Murphy-PFFS-SPOOL-BOM							
Mark	Qty	Description	End 1	End 2	Lft	LDec	Size
1	1	Std Wt SA234 WPB CS BW RED TEE					16x12
11	1	800# FS BB OS&Y Gate Valve SW					3/4
5	1	150lb RF Sch 40 Bore SA105 CS WN Flg					16
6	1	Std Wt SA234 WPB CS BW Cap					16
2	1	3M A105 FS SW 90 Deg El					3/4
7	1	3000# FS Soc-O-Let			1 5/16"	1.313	1x16
8	1	3000# FS Soc-O-Let			1 1/16"	1.063	3/4x16
4	1	Std Wt SA-53B CS SMLS Pipe PE	BEV	BEV	9'-11 7/8"	119.864	16
9	1	Std Wt SA-53B CS SMLS Pipe PE	BEV	BEV	1'-1 1/4"	13.250	16
3	1	Sch 80 A106B CS SMLS Pipe	SW	SW	2"	2.000	3/4
10	1	Sch 80 A106B CS SMLS Pipe	SW	SW	1'-0"	12.000	3/4

DRN JMM	4/9/2021	WUSM RESEARCH BUILDING	
CHK		NRB	
APP			
JOB NO.	210140	SERVICE NAME	
REF.DWG.		HPS	
DRAWING NO./TRACKING NO.	QTY.	SHT/NO	REV
210140-A-UPL1-10	1	1 OF 1	0

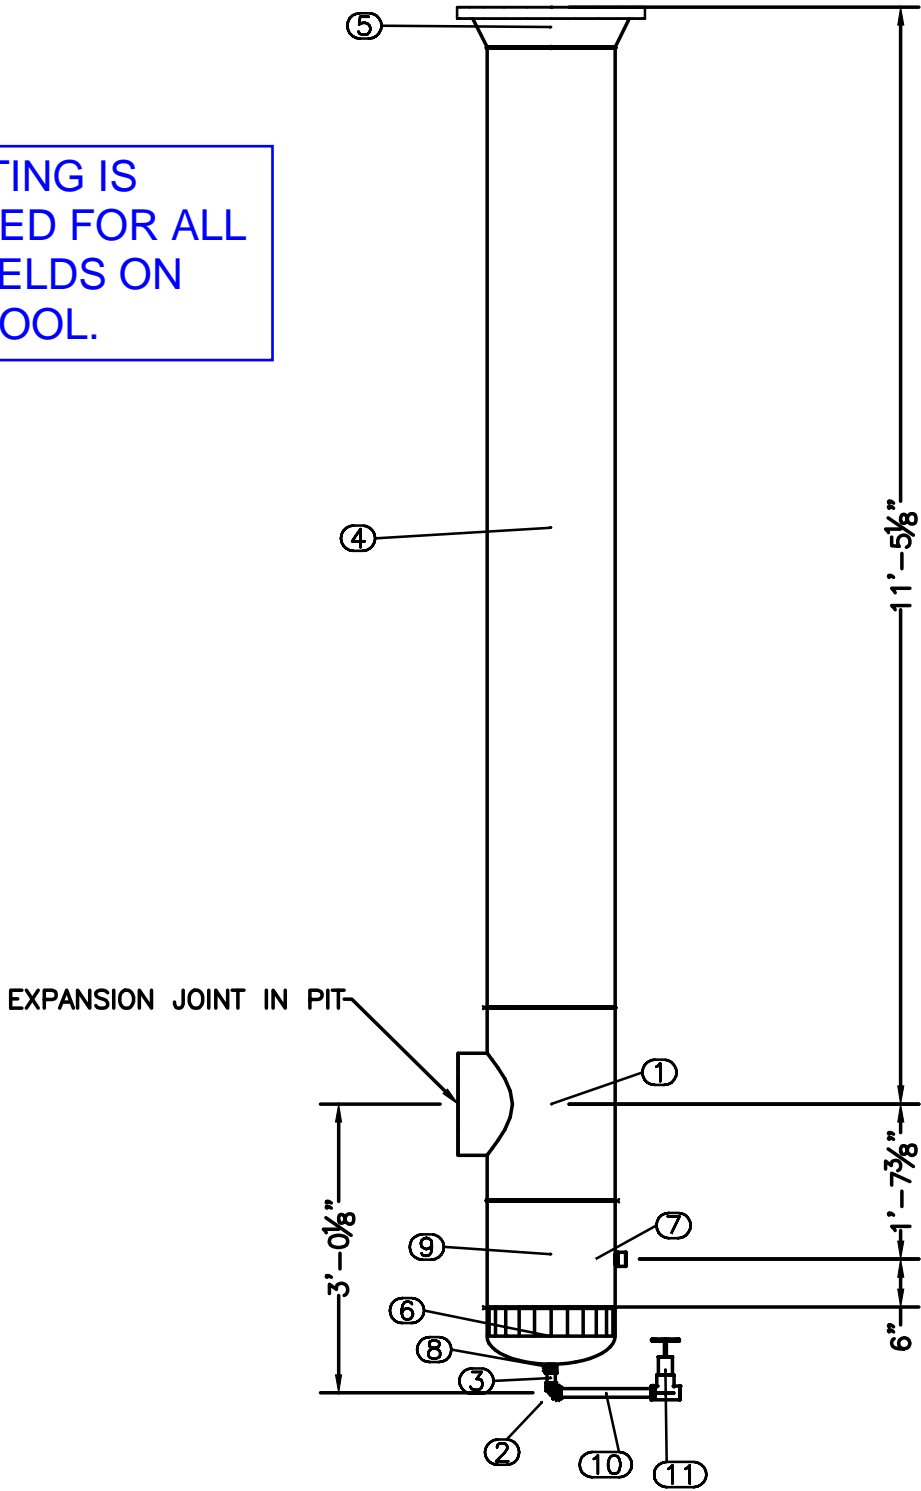
UT TESTING IS  
REQUIRED FOR ALL  
BUTT WELDS ON  
THIS SPOOL.

should be an Apollo  
83A-140 Series  
Ball valve
